Padma Satell Arab Fashions Ltd.(Extension)

Luna Complex Joy Bangla Road, Khaikur, Borobari, Gazipur.

17 February 2025

Observation-2: Discrepancy and missing information in provided drawing (Extension Building).

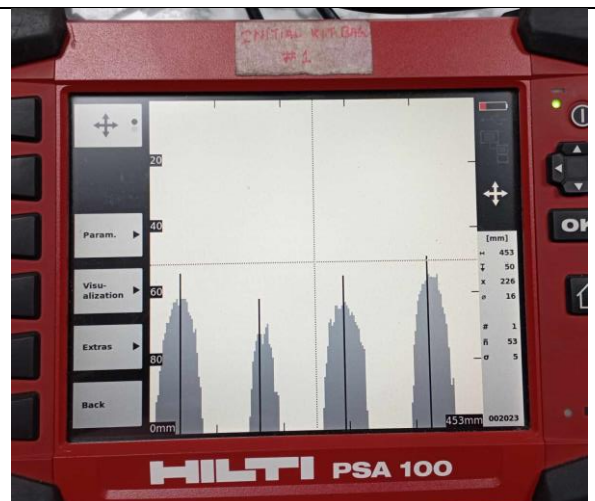
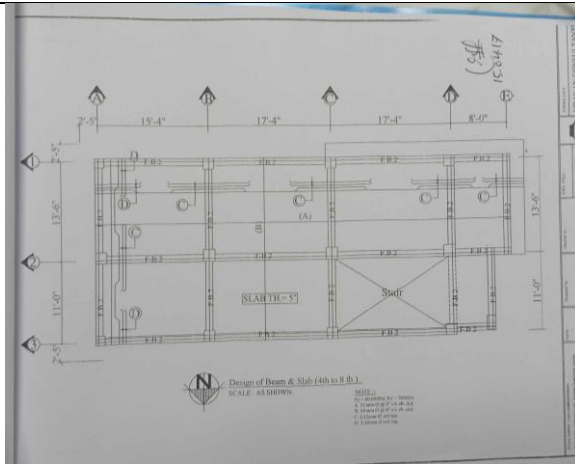
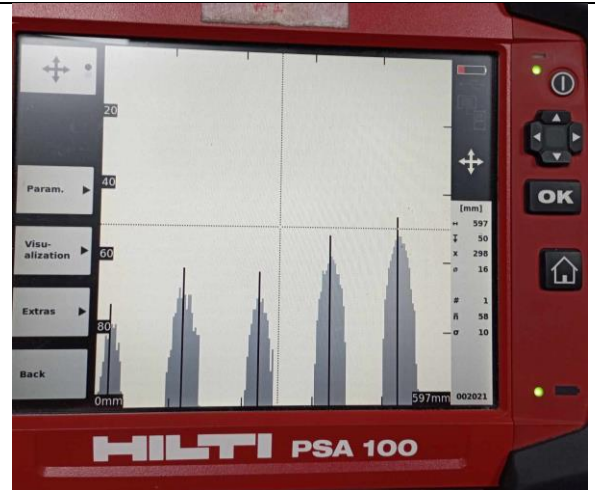
C2: Rebar found 4X4 instead of 5X4 at 7th floor

Details of floor beam not provided

C5: Rebar found 5X5 instead of 6X5 at 4th floor

Description: Details of floor beam not provided in available drawing. Besides, mismatch was found in number of rebar in column as follows: C-2: 4X4 instead of 5X4 at 7th floor, C-4: 5X5 instead of 6X5 at 7th floor, C-5: was found 5X5 instead of 6X5 at 4th floor. The building engineer is required to update the as-built drawing.

2.		Take minimum 4 concrete core from column (lower level).	within 6 weeks
3.		Implement remediation work if required.	within 6 months
4.	Discrepancy and missing information in provided drawing (Extension Building).	The building engineer is required to update the as-built drawing.	within 6 weeks

Observation-3: Crack on beam surface and brick wall (Extension Building).

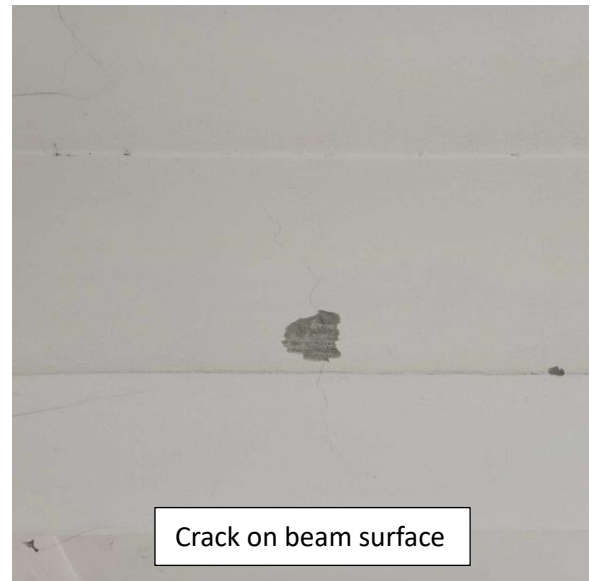
Crack on brick wall

Crack on beam surface

Description: Plaster crack was observed on beam surface and brick wall. The building engineer is required to repair the crack with a suitable method.

5.	Crack on beam surface and brick wall (Extension Building).	The building engineer is required to repair the crack with a suitable method.	within 6 weeks

Observation 4: Lack of load plan (Utility Building).

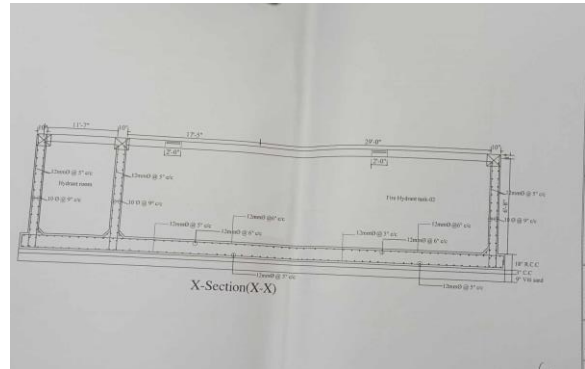
Description: Ground floor is a suspended slab as it is over an underground water tank, but no live load plan was available. The building engineer is required to prepare a floor load plan for ground floor slab.

6.	Lack of load plan (Utility Building).	The building engineer is required to prepare a set of live load plan and submit it to RSC for review.	within 6 weeks

Observation-5: Discrepancy/incomplete drawing (Utility Building).

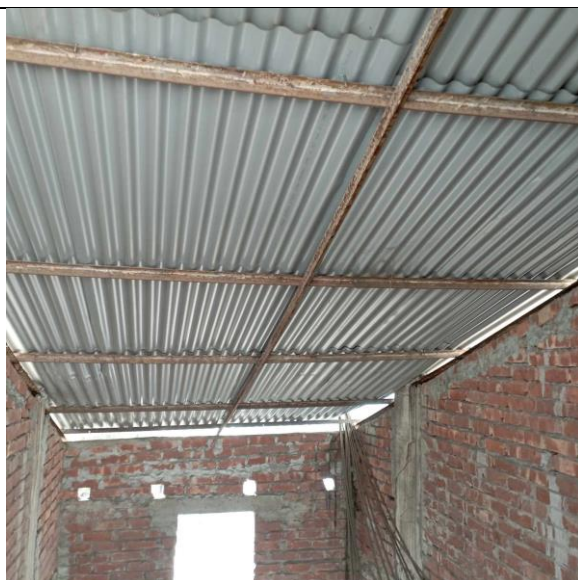
Description: The structure was found as single stoired column schedule provided up to 3rd floor. The factory has not any plan for future extnsion. Also, no information of grade beam and no plan of retaining/tank wall shown in provided drawing. The building engineer is required to prepare a full set of accurate the as-built drawing as per existing condition.

7.	Discrepancy in provided drawing (Utility Building).	The building engineer is required to update the as-built drawing.	within 6 weeks
8.	Falling hazard at roof and staircase (Utility Building).	The building engineer is required to provide edge protection to avoid falling hazard.	within 6 weeks
